EASA	AIRWORTHINESS DIRECTIVE	
	AD No.: 2012-0083	
	Date: 16 May 2012	
C.	Regulation (EC) No 216/20	Directive (AD) is issued by EASA, acting in accordance with 08 on behalf of the European Community, its Member States and tries that participate in the activities of EASA under Article 66 of
continuing airworthiness of an an aircraft to which an AD app	aircraft shall be ensured by accompli lies, except in accordance with the re	3. In accordance with EC 2042/2003 Annex I, Part M.A.301, the ishing any applicable ADs. Consequently, no person may operate equirements of that AD unless otherwise specified by the Agency of the State of Registry [EC 216/2008, Article 14(4) exemption].
Type Approval Holder's Name :		Type/Model designation(s) :
AIRBUS		A318, A319, A320 and A321 aeroplanes
TCDS Number:	EASA.A.064	
Foreign AD:	Not applicable	
Supersedure:	This AD supersedes EASA	AD 2011-0167 dated 06 September 2011.

ATA 35	Oxygen – Chemical I Identification / Modif	Emergency Oxygen Containers – ication
Manufacturer(s):	Airbus (formerly Airbus Industrie)	
Applicability:	Airbus A318-111, A318-112, A318-121, A318-122, A319-111, A319-112, A319-113, A319-114, A319-115, A319-131, A319-132, A319-133, A

Appendix 1 – Design A of the Passenger Oxygen Containers affected by this AD

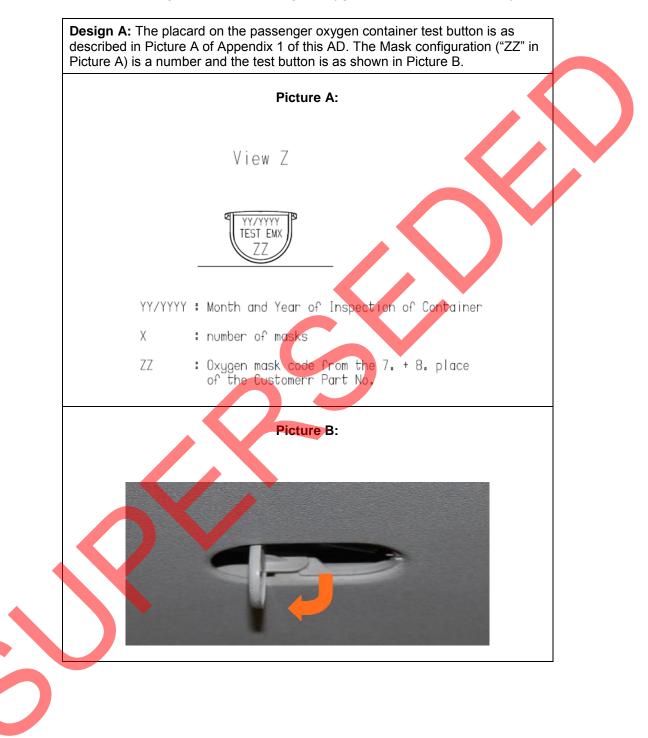
(1) Before the accumulation of 5 000 flight cycles, or 7 500 flight hour 24 months, whichever occurs first after 20 September 2011 [the effective date of EASA AD 2011-0167], identify the Part Number and serial number (s/n) of each passenger oxygen container insta on the aeroplane. A review of aeroplane maintenance records is acceptable to accomplish the identification as required by this paragraph, provided those records can be relied upon for that purpose.		
	<ul> <li>(2) If the P/N <u>and</u> s/n of a container, identified as required by parag (1) of this AD, are listed, respectively, in Table 1 (P/N) and Table (s/n) of this AD, accomplish the following actions concurrently, we the compliance time as specified in paragraph (1) of this AD, in accordance with the instructions of Airbus Service Bulletin (SB) 35A1047:</li> </ul>

(2.1) Replace the oxygen generator man container with a serviceable man		
	(2.2) Perform an operational check of t	he manual mask releas	
	(2.3) Check if the P/N of the container is listed in B/E Aerospa 1XCXX-0100-35-005 Revision 01, or B/E Aerospace SB 22CXX-0100-35-003 Revision 01, and if is not listed, cor Airbus for instructions and accomplish those instructions accordingly.		
		plish those instructions	
	accordingly.	Numbers	
	accordingly. Table 1 – Affected Part (xxxx stands for any alphanu	Numbers	
	accordingly. Table 1 – Affected Part (xxxx stands for any alphanu Type I: 15 and 22 minutes Type II:	Numbers merical value)	
	accordingly. Table 1 – Affected Part (xxxx stands for any alphanu Type I: 15 and 22 minutes Type II: 12C15Lxxxxx0100 22C	Numbers merical value) 15 and 22 minutes	
	accordingly. Table 1 – Affected Part (xxxx stands for any alphanu Type I: 15 and 22 minutes Type II: 12C15Lxxxxx0100 22C 12C15Rxxxxx0100 22C	Numbers merical value) <b>15 and 22 minutes</b> 15Lxxxxx0100
